**Objection to the proposed removal of part of the Zone C1 permit holder parking place outside No. 38 Bullrush Grove, Cowley to accommodate a new vehicle crossover extension**

# Objection to the proposed removal of part of the Zone C1 permit holder parking place outside No. 38 Bullrush Grove, Cowley to accommodate a new vehicle crossover extension

Appendix A - Plan – Proposed amendments outside No. 38 Bullrush Grove, Cowley to accommodate a vehicle crossover extension

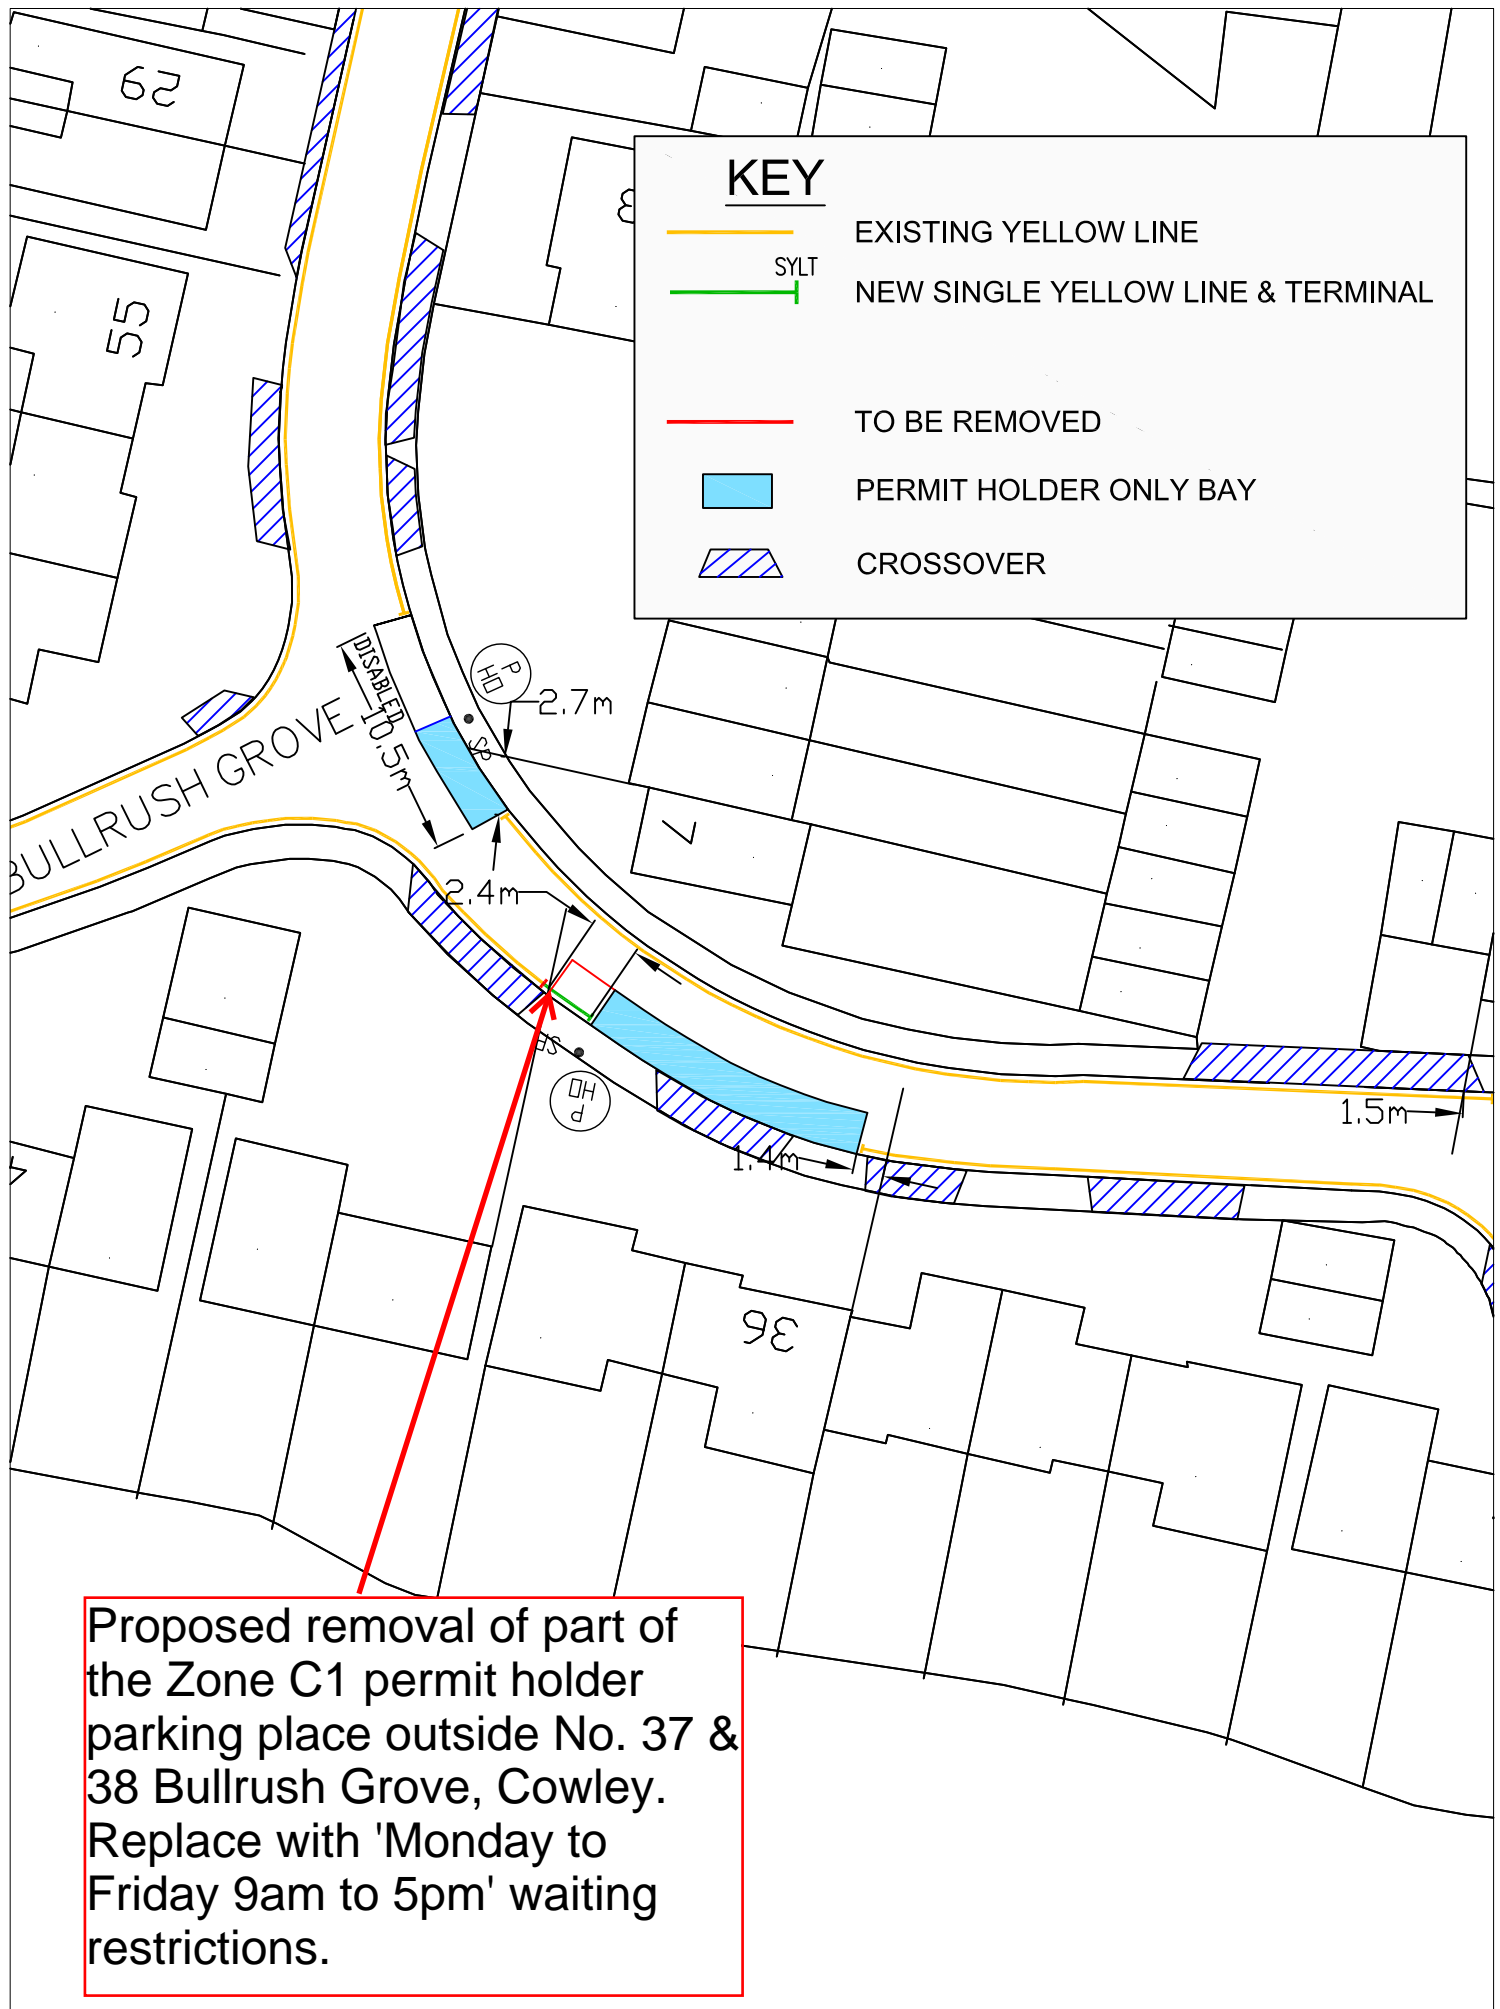
*"I am writing to object to the removal of a Section of C1 parking outside 37 & 38 Bullrush Grove.*

*Since the parking restrictions were installed in 2011 I have had problems entering and exiting my drive when vehicles are parked close to the end of the bay that is*

*outside 37 Bullrush Grove. I have attached two videos showing the issues I face. The videos show a small car parked close to the edge of the bay but when SUV's, vans and open top lorries are parked in the same way the problem is exacerbated where I end up having to make numerous manoeuvres to create an angle to exit the drive by driving over my path and front lawn and this is cracking my path.*

*If you reduce the width of the parking bay then every vehicle will be forced to park at the end of the bay causing me these issues. I do not understand why the bay needs to be reduced outside properties 38 & 39 as the width of the drive available already is twice the width of my drive. The common-sense approach would be to reduce the width of the bay outside my property.*

*I also have issues whereby Vans and lorries already overhang the parking bay and onto the white lines that are in place and when I complain it has been pointed out to me that this is not illegal as these are white not yellow lines?*

*I am happy for you to send someone to my property to review what I am saying and test out parking into both driveways.*

*What I would like to see is either*

*1. The width of the parking bay is only reduced from outside properties 37 & 38 Bullrush Grove*

*2. The parking bay is removed completely and replace with no waiting lines"*

5. This resident's main concern with the changes as proposed as a consequence of the driveway crossover alterations, is that the resulting reduction to the length of the parking place could, they believe, potentially cause vehicles to park closer to their own dropped kerb and cause them an obstruction when trying to access their off-street parking. Since the resident opposing these changes has a continuous parking bay across their driveway, there is the potential another vehicle could block their access in which case the Council would be limited to what enforcement action could be taken since the vehicle would be parked wholly within a designated parking space. A white bar marking already exists outside the dropped kerb, but since this is only a guidance marking it does not give the Council any further powers of enforcement against obstructive parking.

6. The Council's Highways Delivery Manager has reminded the Cabinet Member that the public have a legal right to gain access to their property from the highway. When determining an application for a new vehicle crossing, Section 184 of the Highways Act gives guidance to Highway Authorities in so much as they are only able to ensure that, so far as is practicable, there is safe access to and egress from the premises and there is a need to facilitate so far as practicable the passage of vehicular traffic in highways. The Highways Authority should also take into consideration any physical obstruction preventing the installation. In this case the Council's Highways officers have assessed the objection submitted above along with the videos provided and have identified no legal basis to reject the application. They have therefore asked that the legal process is completed and to

proceed with the installation of this vehicle crossing extension. They have also commented that removal of the parking bay outside the drive of the objector as suggested would only be considered if they submitted a similar application for a crossover extension.

7. For the reasons above, the Council's Highways Delivery Manager states that the Council cannot refuse this crossover extension request as it complies with its Crossover Policy and the existing extent of the parking bay will remain unaltered. On that basis the Highways Delivery Manager has specifically asked that the proposals are progressed as advertised. It is therefore recommended to proceed with the changes to the parking outside No. 38 Bullrush Grove as proposed and indicated on Appendix A.
